ADDENDUM NO. 03

June 21, 2024

Additions and Renovations to Franklin Central High School Phase 2B
6215 S. Franklin Rd.
Indianapolis, IN, 46259

Drawing No: T201J&M

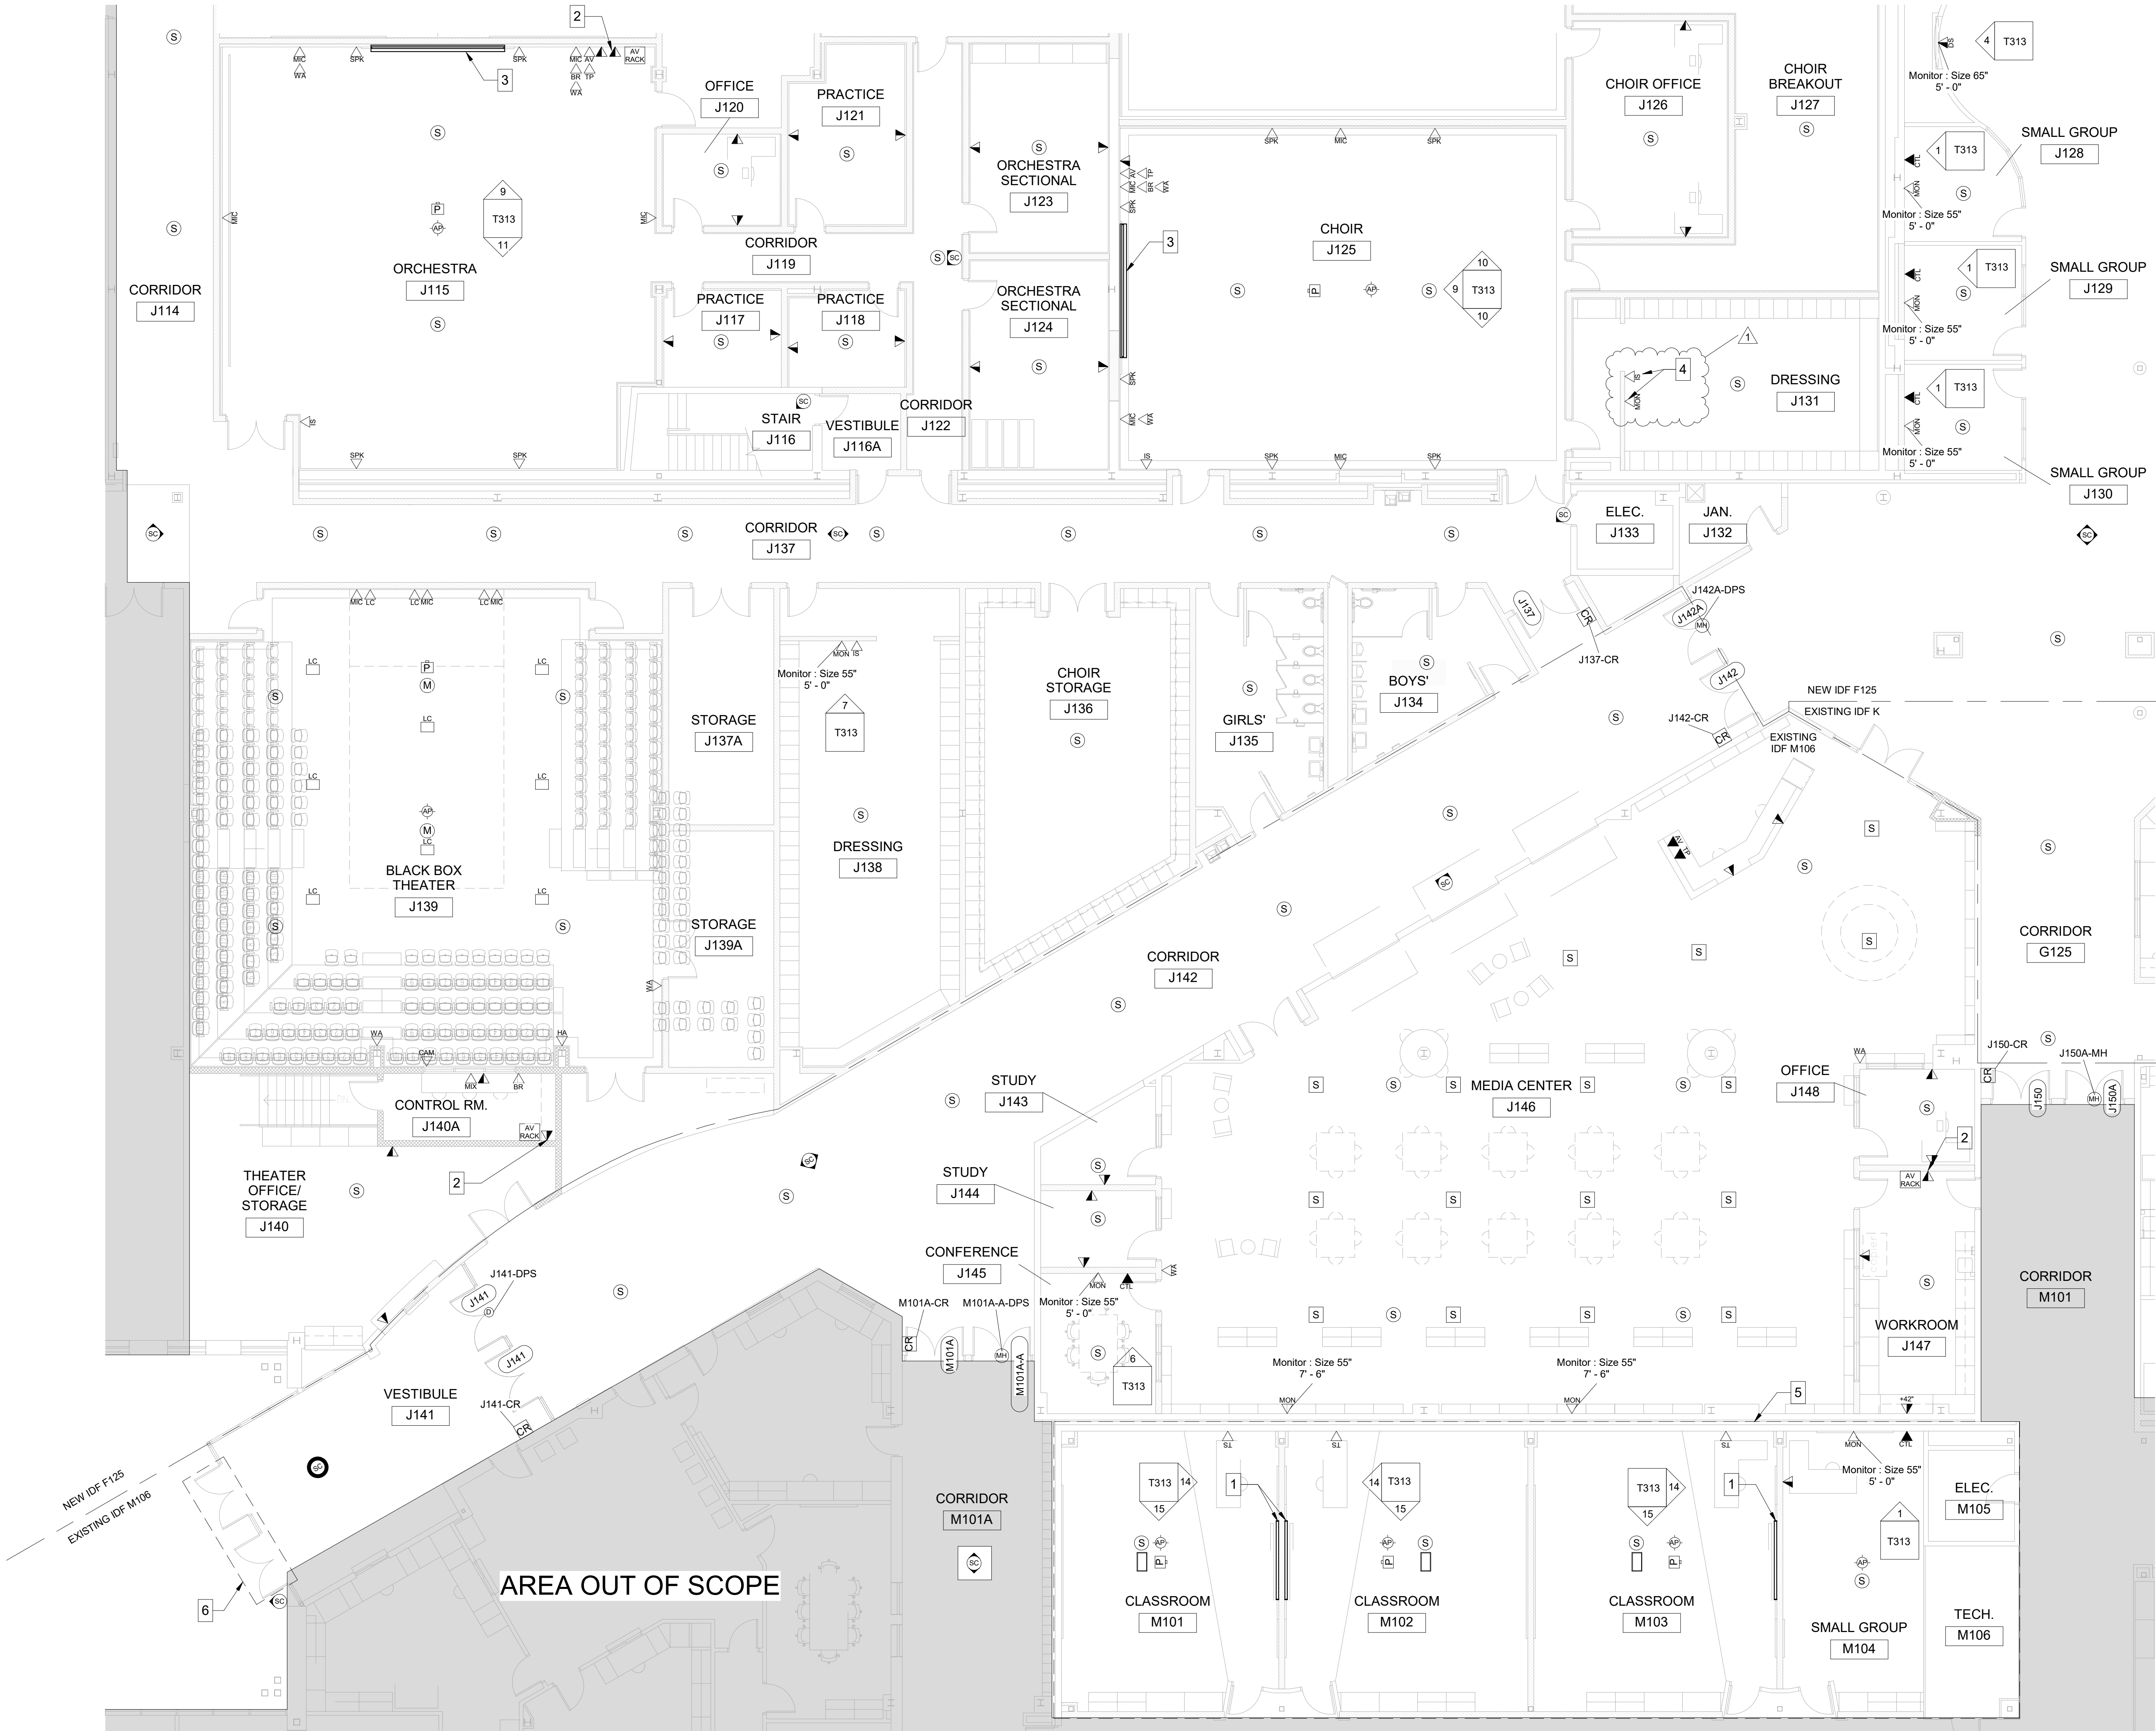
1. T201F – FIRST FLOOR TECHNOLOGY PLAN – UNIT F
 - a. Added intercom speaker station rough-ins.
2. T201J&M – FIRST FLOOR TECHNOLOGY PLAN – UNITs J&M
 - a. Added intercom speaker station rough-ins.
3. T305 – AV DIAGRAMs
 - a. Updated theater intercom diagram.
